11/14/97	Plan revised to indicate pedestrian and bicycle safe grate GDI's.
DATE	REVISION
STATE OF HAWAII DEPARTMENT OF TRANSPORTATION HIGHWAYS DIVISION	
DRAINAGE PLAN	
VOLCANO RD. DRAINAGE IMPROVEMENTS	
Vicinity of Keau Town	
F.A. Proj. No. STP-011-2(30)	
Scale: 1"=40'	Date: Oct 1997
SHEET No. <i>HI</i> OF 6 SHEETS

DRAINAGE DETAILS
VOLCANO RD. DRAINAGE IMPROVEMENTS
Vicinity of Keaau Town
F.A. Proj. No. STP-011-2(30)
Scale: 3/4" = 1'-0"
Date: Oct 1997

STATE OF HAWAII DEPARTMENT OF TRANSPORTATION HIGHWAYS DIVISION
DRAINAGE DETAILS
VOLCANO RD. DRAINAGE IMPROVEMENTS Vicinity of Keaau Town F.A. Proj. No. STP-011-2(30)
Scale: 3/4" = 1'-0" Date: Oct 1997
SHEET No. H4 OF 6 SHEETS

DETAIL OF TYPE 61614P & 61616P STEEL FRAME & GRATES

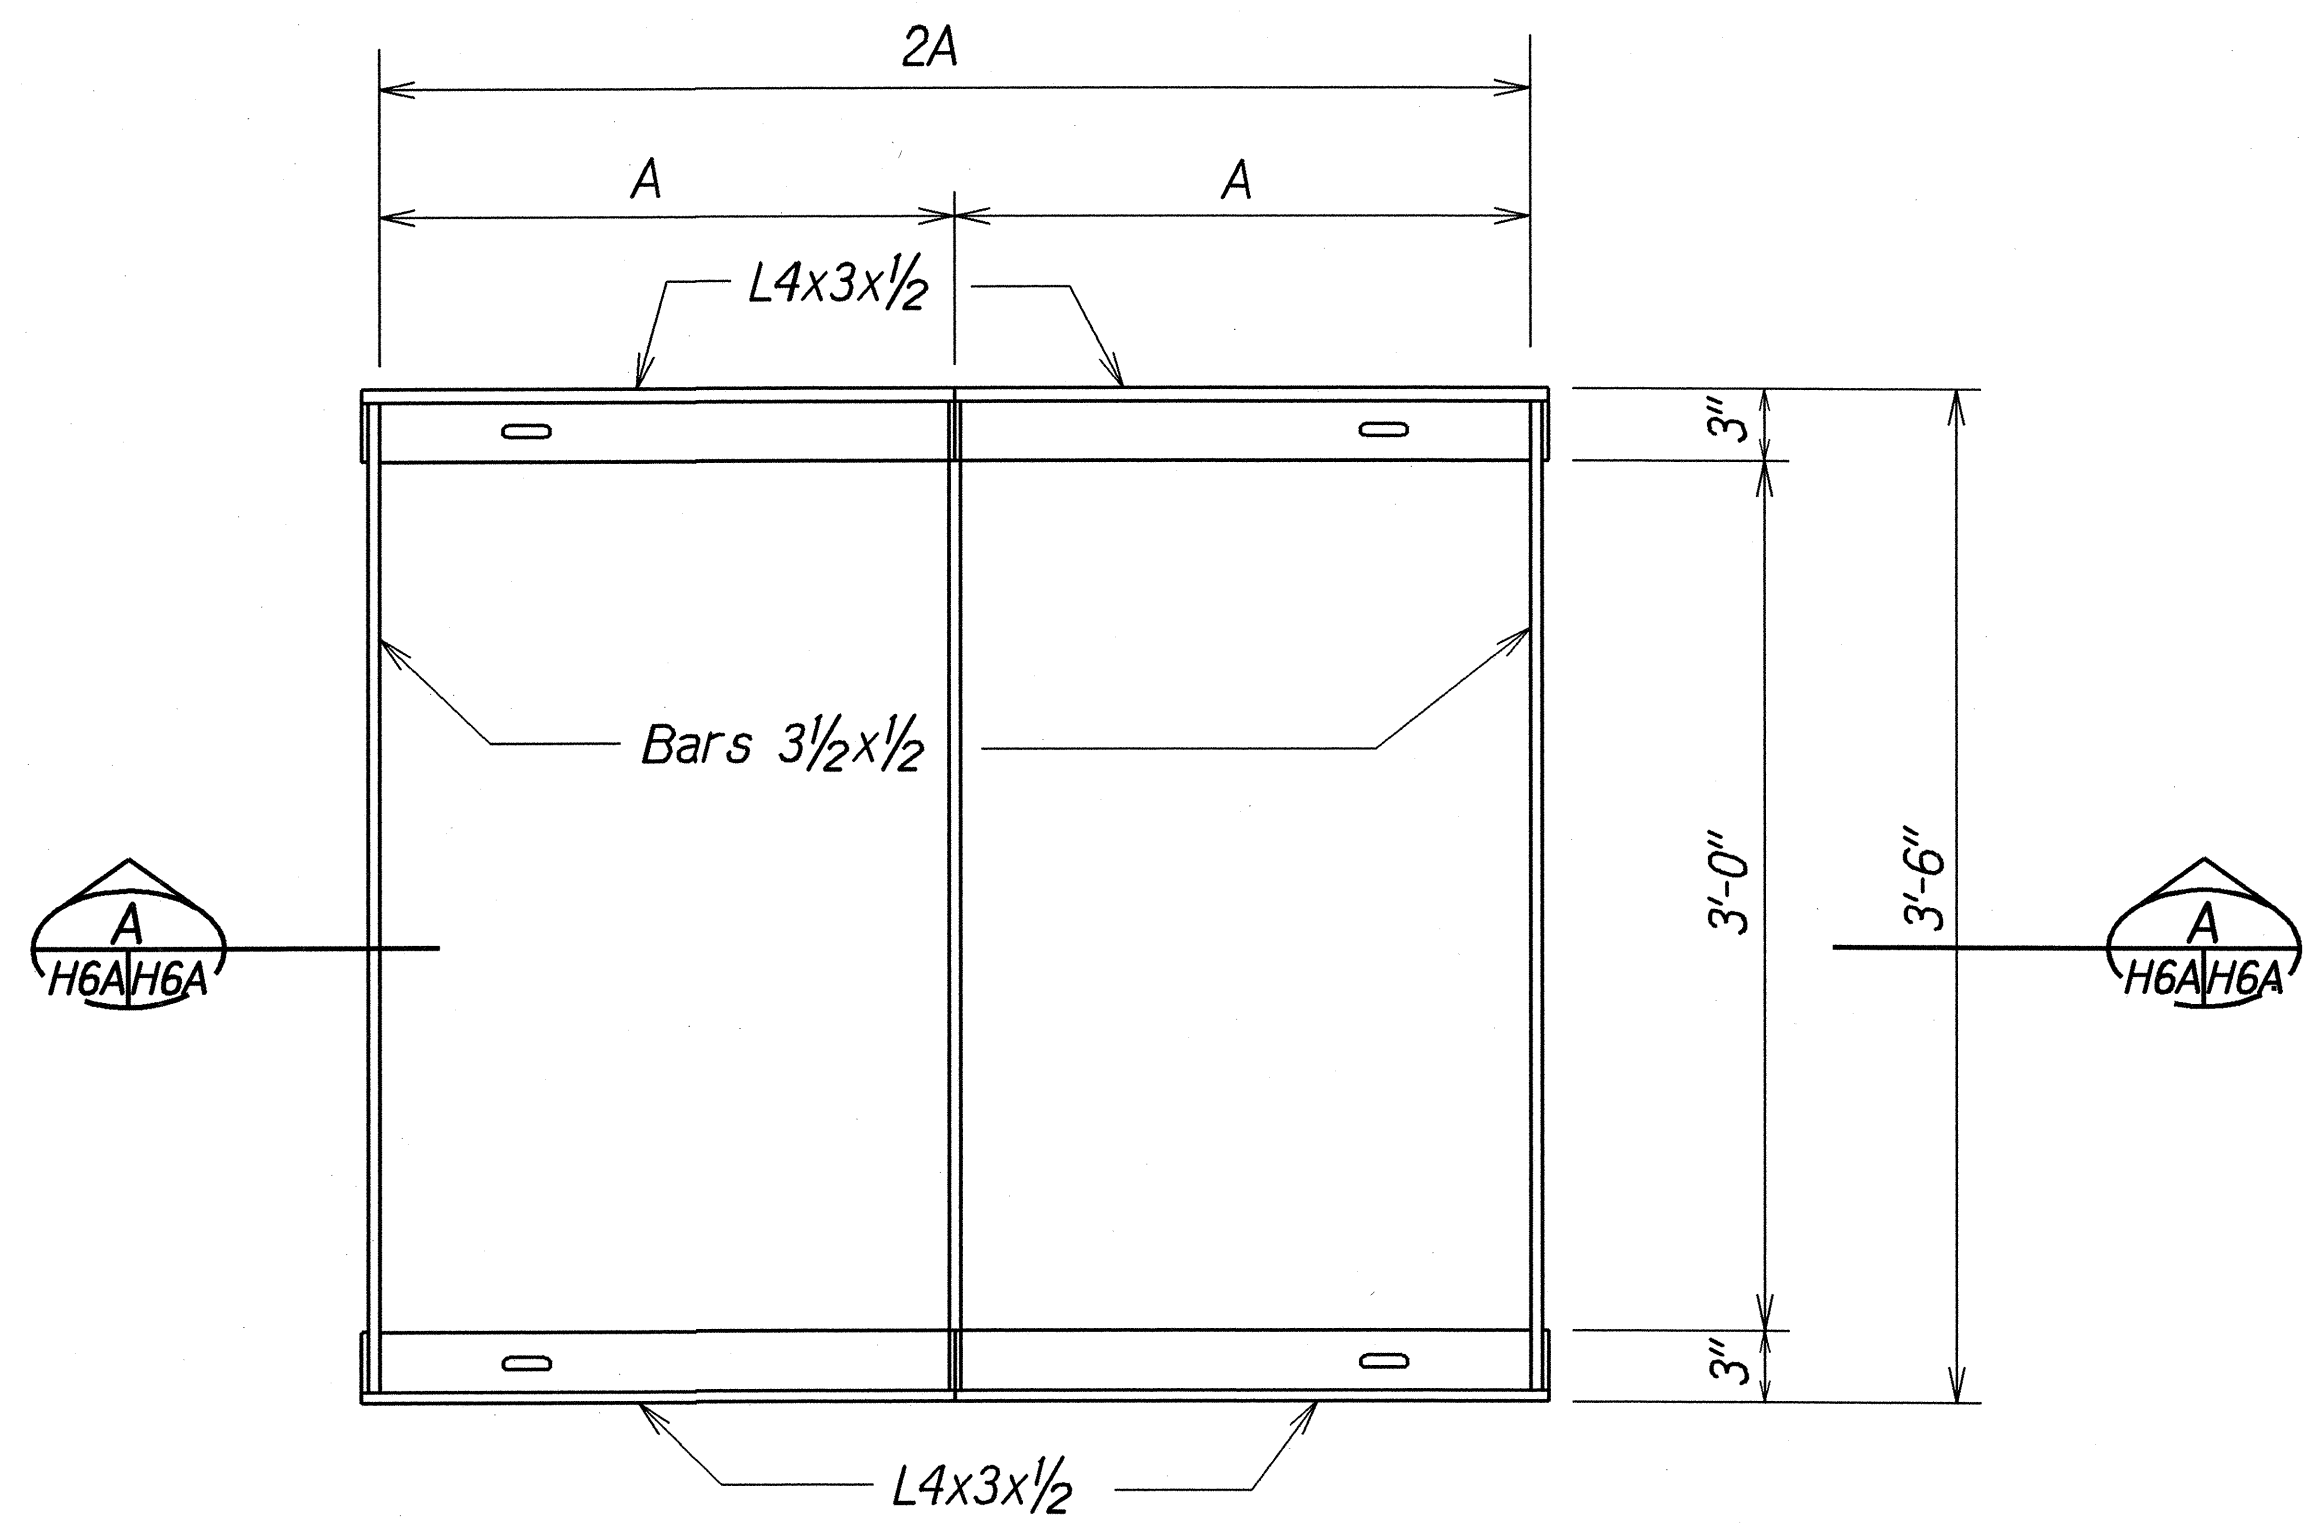
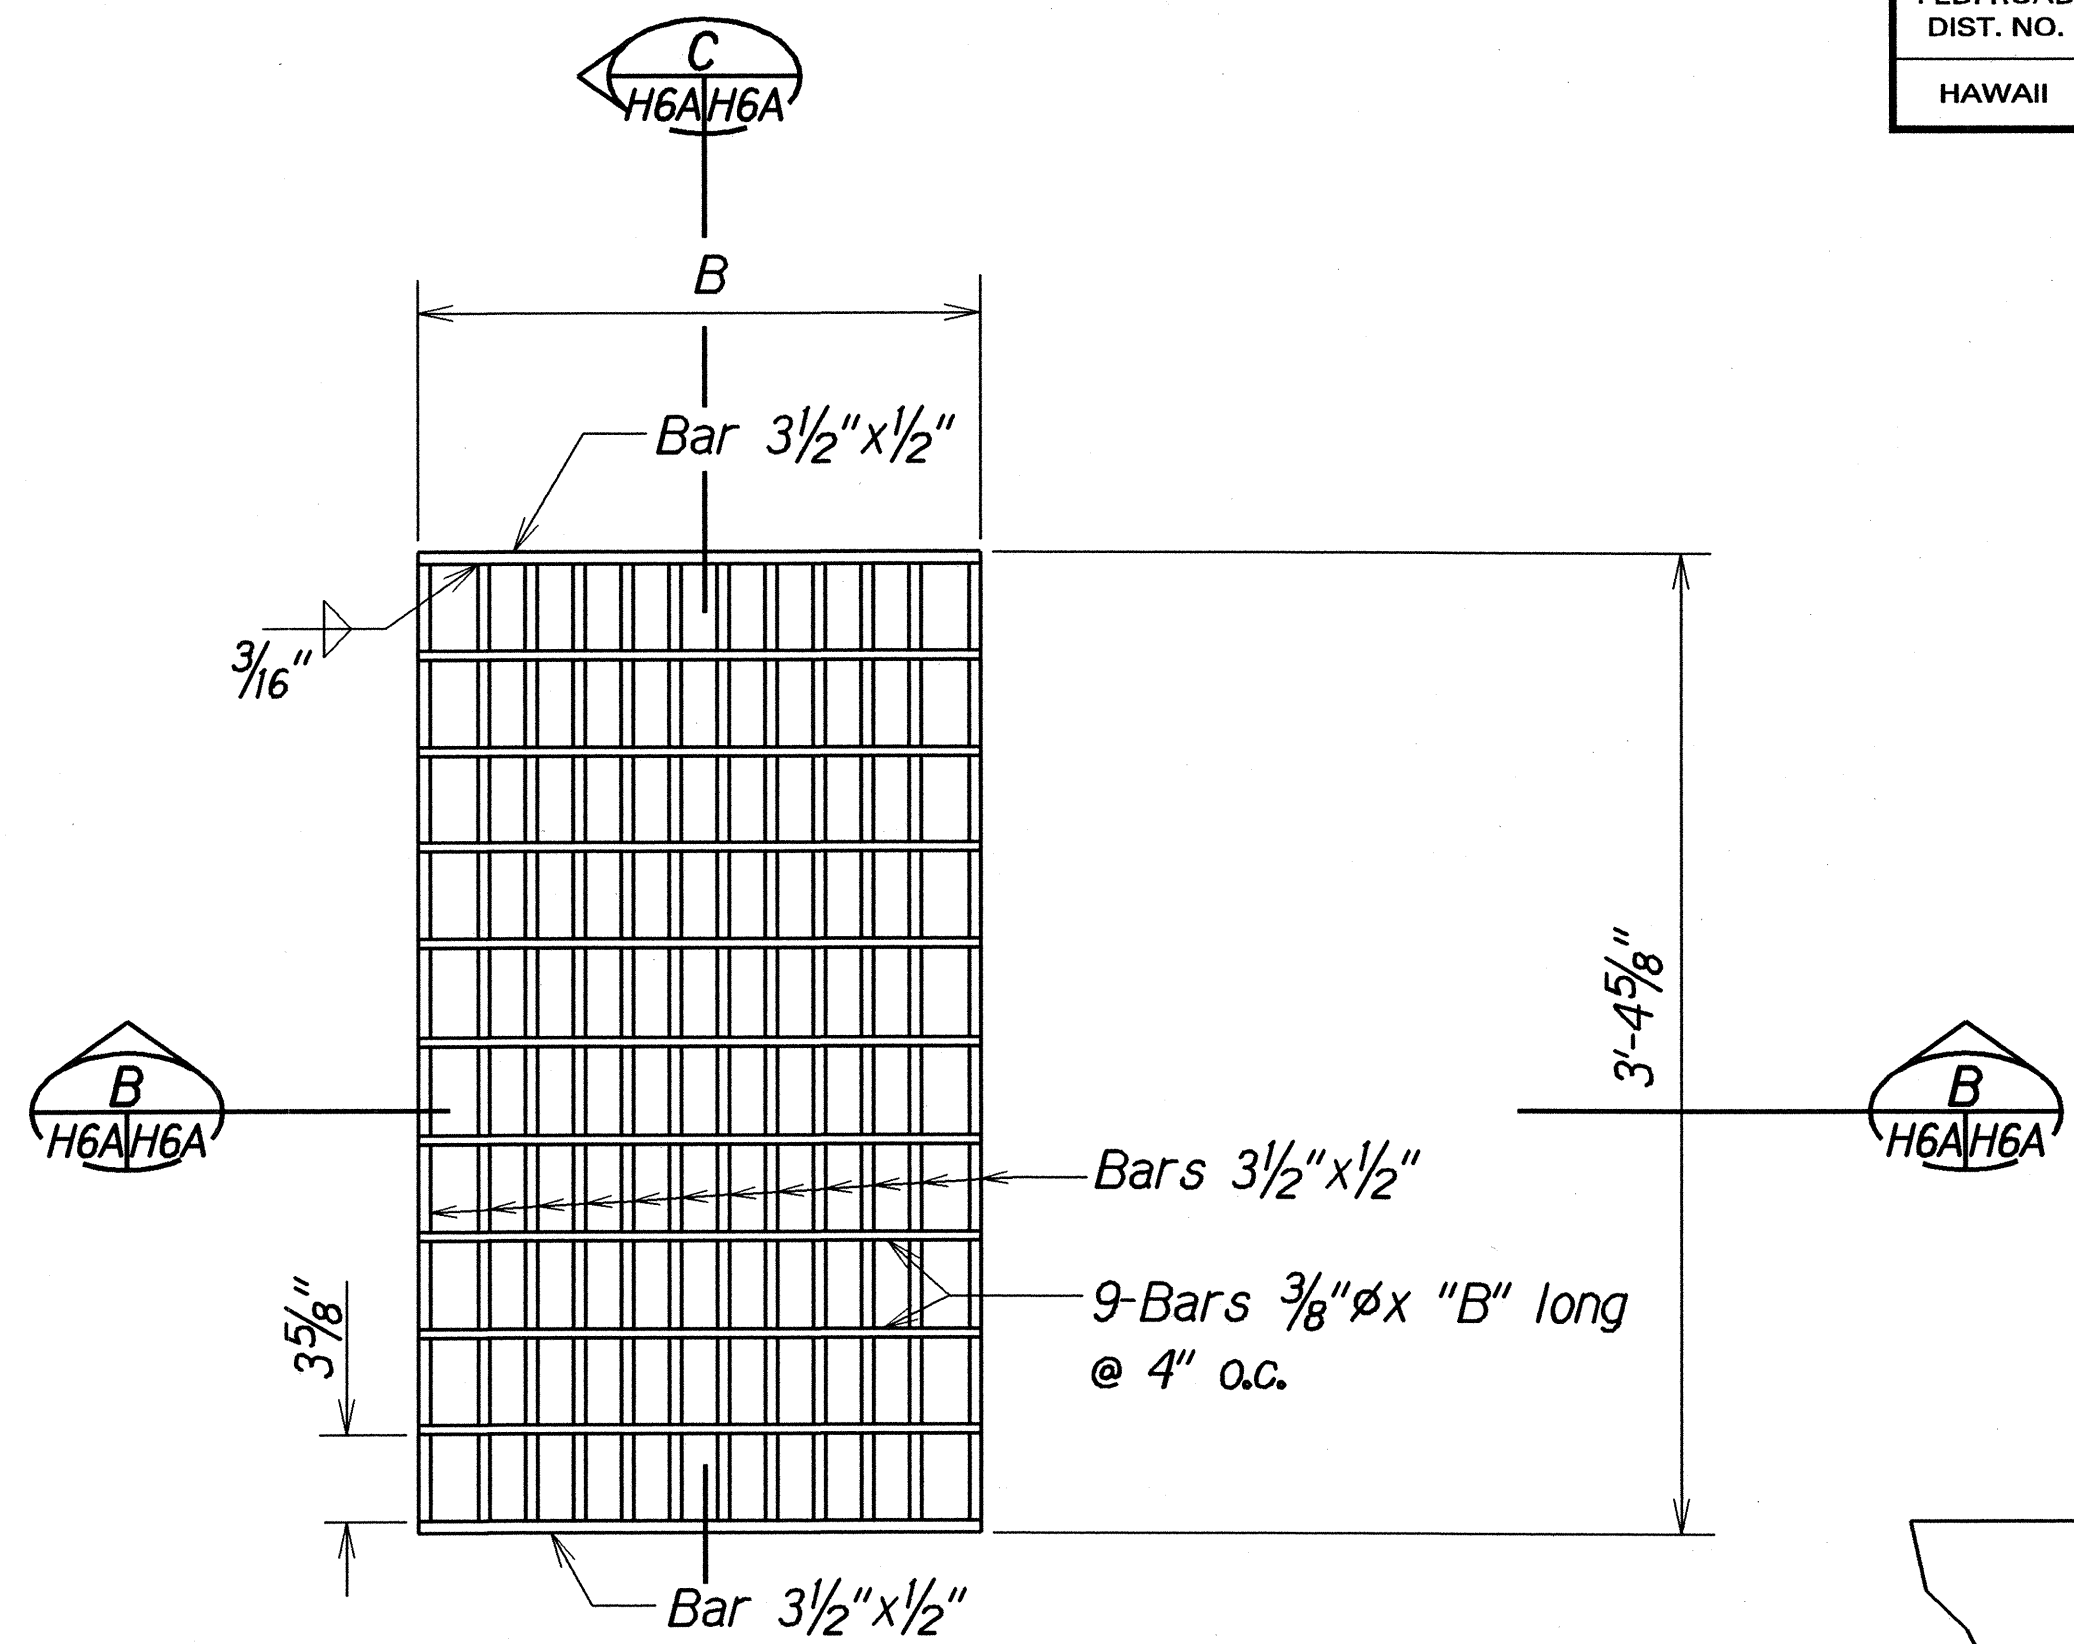
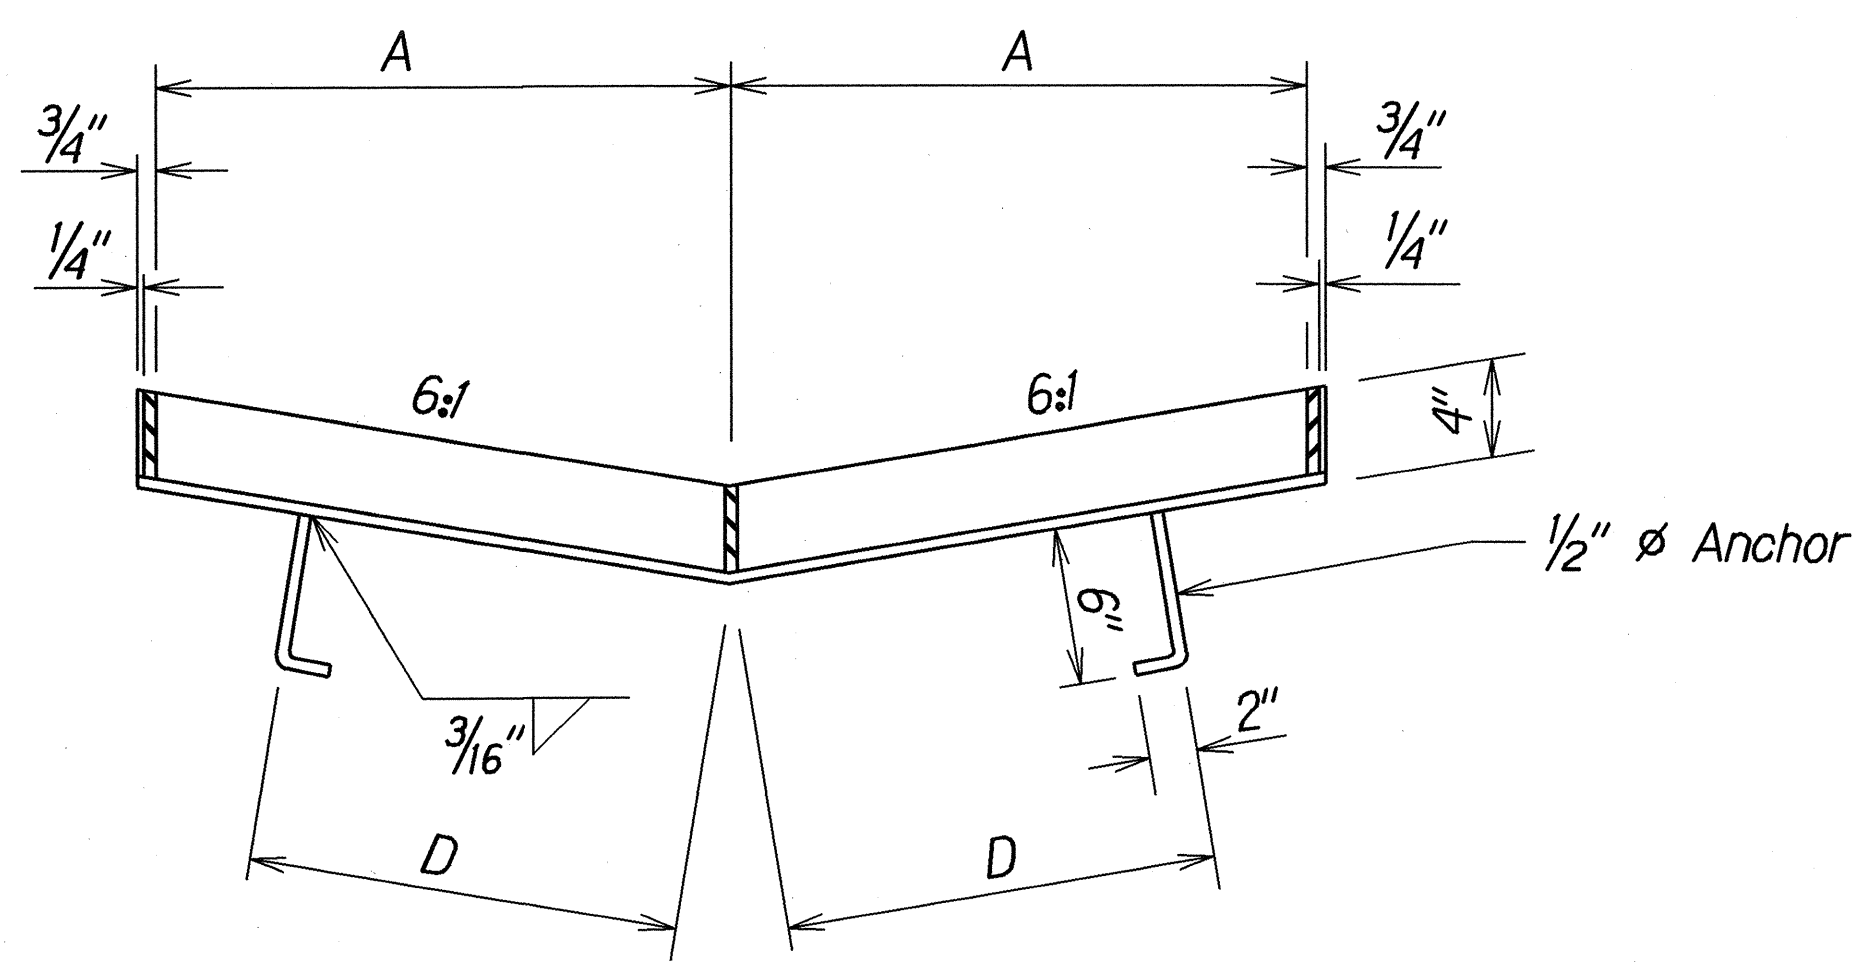
11/14/97	Sheet added to show details of pedestrian and bicycle safe frame & grates.
DATE	REVISION
STATE OF HAWAII DEPARTMENT OF TRANSPORTATION HIGHWAYS DIVISION DRAINAGE DETAILS VOLCANO RD. DRAINAGE IMPROVEMENTS Vicinity of Keaau Town F. A. Proj. No. STP-011-2(30) Scale: 1 1/2" = 1'-0" Date: Nov. 1997 SHEET No. H6A OF 6 SHEETS
